UNITED STATES
NUCLEAR REGULATORY COMMISSION
WASHINGTON, D.C. 20555-0001

SUBJECT: THREE MILE ISLAND NUCLEAR STATION, UNIT 1 – SAFETY EVALUATION
REGARDING IMPLEMENTATION OF MITIGATING STRATEGIES AND
RELIABLE SPENT FUEL POOL INSTRUMENTATION RELATED TO ORDERS
EA-12-049 AND EA-12-051 (CAC NOS. MF0803, AND MF0866)

Enclosure:
Safety Evaluation

Figure 1 - "TMI SFP Levels of Monitoring"

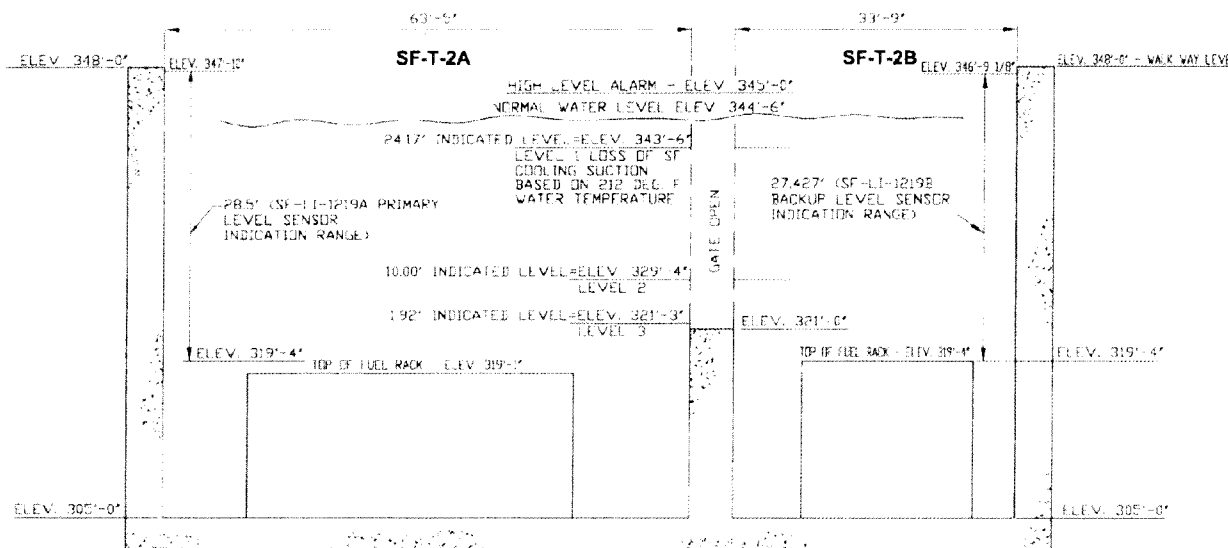
In its letter dated January 20, 2016 [Reference 31], the licensee revised the Level 1 from 340ft. 4in. to 343ft. 6in. plant elevation and Level 3 from 319ft. 4in. to 321ft. 3in. plant elevation. Per this letter, for the modified Level 1, the licensee stated that accordance to Calculation C-1101-251-E410-012, "Available NPSH for SF Coolant Pumps," loss of suction by vortexing is as high as 341ft. 11in. at the design flow of 1000 gpm. Under saturated conditions, at design flow of 1,000 gpm and 212°F fluid, adequate NPSH exists and suction line voiding will not occur at 343ft. 6in. For the modified Level 3, the licensee stated that Level 3 is slightly above the top of the gate weir that separates the two SFPs, which is elevation 321ft. 0in., rather than the top of the fuel rack, which is elevation 319ft. 1in. According to the licensee, this change will provide assurance that both the primary and backup SFP level instrument channels can measure the same Level 3 elevation in both SFPs.

The NRC staff's assessment of the licensee selection of the SFP levels of monitoring is as follows: per NEI 12-02, Section 2.3.1, Level 1 will be the higher of two points. The first point is the water level at which suction loss occurs due to uncovering of the spent fuel cooling inlet pipe. This was identified by TMI as elevation 341ft. 11in. The second point is the water level at which loss of spent fuel cooling pump NPSH occurs under saturated conditions. This was identified by TMI as below elevation 343ft 6in. The Three Mile Island designated Level 1 (343ft. 6in.) is the HIGHER of the above two points and therefore consistent with NEI 12-02. Level 2 was identified as elevation 329ft. 4in. This level is consistent with the first of the two NEI 12-02 options for Level 2, which is 10 feet (+/- 1 ft.) above the highest point of any fuel rack seated in the SFP. Level 3 is consistent with NEI 12-02 Level 3, which is above the highest point of any fuel rack seated in the SFP.

In its letter dated January 20, 2016 [Reference 31], the licensee provided a sketch depicting the final SFP levels of monitoring and the instrument measurement ranges (Figure 1 of this evaluation). In this figure, the measurement range for the primary channel is from 347ft. 10in. to 319ft. 4in. plant elevations. The measurement range for the backup channel is from 346ft. 9 1/8in. to 319ft. 4in. plant elevations. The NRC staff noted that the instrument measurement ranges will cover Levels 1, 2, and 3, as described in Section 4.1 above. However, the staff had concerns regarding the possible effects on the reliability of the SFP level instrumentation when the gate is closed. In its letter dated August 28, 2015 [Reference 32], the licensee provided a response to the staff's concern, in which it stated that complete redundant monitoring of the SFPs will not be available when the gate between SFP "A" and "B" is installed. This gate has not been installed for more than 37 years. It was installed to re-rack the SFP "B" at that time. There is no intention to install the gate in the future. If the gate is installed, there is an existing Procedure 1507-2, "Fuel Handling Building Crane Operation," to install and remove the gate. According to the licensee, Procedure 1507-2 will be revised to establish administrative guidance/controls to follow the NEI 12-02, Section 4.3 guidance for the 90-day out of service criterion. Furthermore, during the onsite audit, the licensee stated that Procedure CC-TM-118-1001, "TMI Diverse and Flexible Coping Strategy (FLEX) Program Document," will be revised to include SFP instrumentation (SFPI) channel unavailability actions. The staff found that the licensee adequately addressed the staff's concerns with regard to the effects on the reliability of the SFP level instrumentation caused by the gate installation.
